# UNITED STATES PATENT AND TRADEMARK OFFICE

10/579,194

<b>Office Action Summary</b>	<b>Application No.</b> 10/579,194	<b>Applicant(s)</b> LEE ET AL.	
	<b>Examiner</b> Krishnan S. Menon	<b>Art Unit</b> 1797

## DETAILED ACTION

Fig. 9

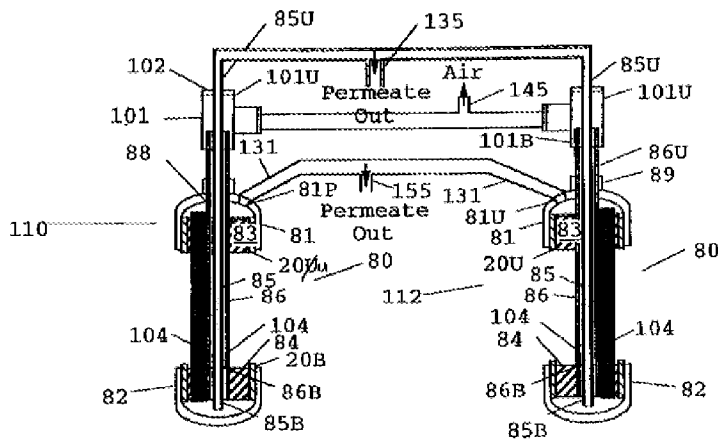
The only element missing here is the plural support tubes, and support tube itself having separate air holes. However, as can be seen in fig 9 below, the reference teaches plural such bundles interlinked with plural air tubes as support and air diffusers.

Fig. 7

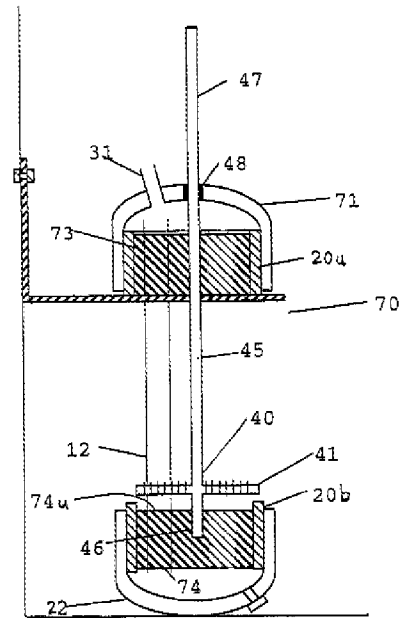
**(1) Henshaw, et al, (US 5,783,083):** Henshaw teaches hollow fiber bundles potted with headers on both ends (see fig. 7 below), with an air diffusion tube (45) supportively separating the headers and having air diffusion pipes (41) branching off

from it located withing the bundle and between the hollow fibers as claimed in claim 1.

The missing elements are obvious to one of ordinary skill in the art from the teaching of this reference itself – there is nothing patentable in having plural pipes 45 with pipes 41 in larger sized modules as in Fig 7. Also, the Ohkubo reference below teaches providing plural air tubes/support tubes – one of ordinary skill in the art would combine the teachings of these references to arrive at the applicant’s invention for the reasons taught by Ohkubo, such as for larger modules.

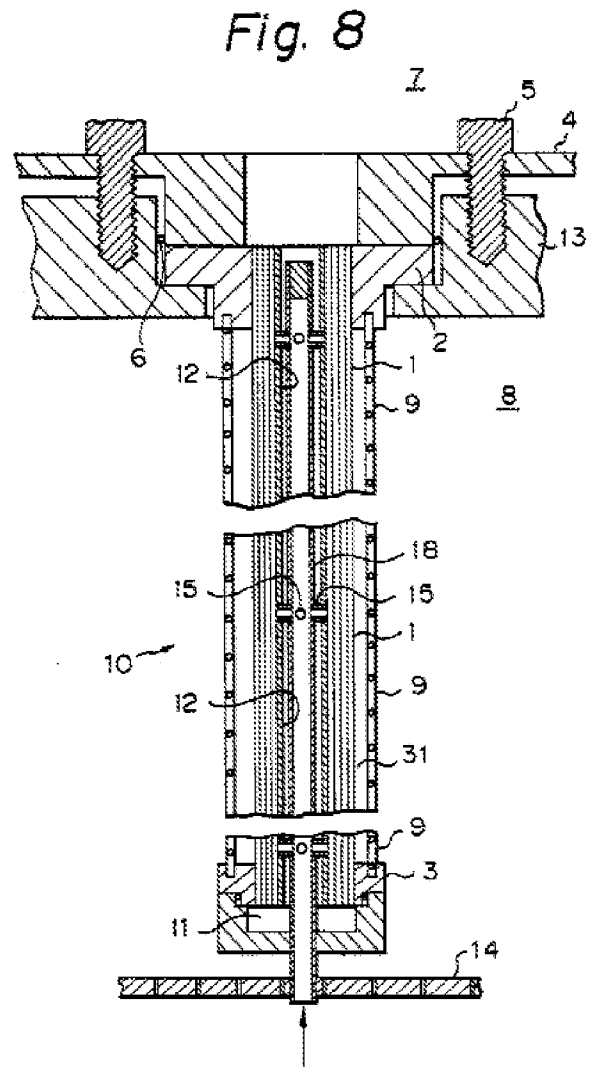
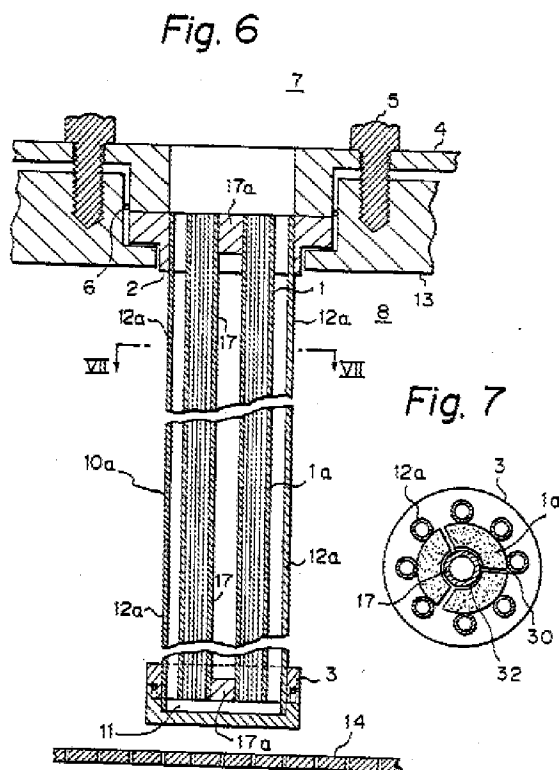
**(2) Ohkubo et al (US 4,876,006):** Ohkubo teaches hollow fiber modules having potted headers at both ends and connected by support tubes having air diffusion tubes as claimed in claim 1 - see the figures copied below, as well as the excerpts from column 5. It is clear from the teaching that there can be plural support tubes with plural air holes, the plural air holes having extended tube nozzles (see 15 in fig 8). The cited paragraph also provide3s different combinations of the design which make the claimed invention obvious. Also, it would be obvious to combine the teaching of this reference with that of Henshaw to have the horizontal air distribution pipes (41) of Henshaw in the teaching of Ohkubo to have more air distribution.

When the dimension of the bundles 1a is large, it is preferable to provide an air pipe or plural air pipes 18 provided with plural air injection nozzles 15 outside the conduit 12 as schematically shown in FIG. 8, the pipe or pipes 18 being plugged at the top and open at the 25 bottom thereof. With the provision of the air injection nozzles 15 extending into the air pipe 18, air bubbles injected through the nozzles promote the removal of cakes particles from the fibers. It is further preferable to dispose nozzles 15 adjacent the upper and lower bundle 30 plates 2 and 3 so that the sedimentary deposit of particles on these plates may be removed by the air injected from the nozzles 15. Alternately, the conduit 12 may be disposed inside the air pipe 18. In the case of the modified module such as that shown in FIGS. 6 and 7, the 35 reinforcing pipe 17 may be modified as an air pipe similar to the pipe 18.
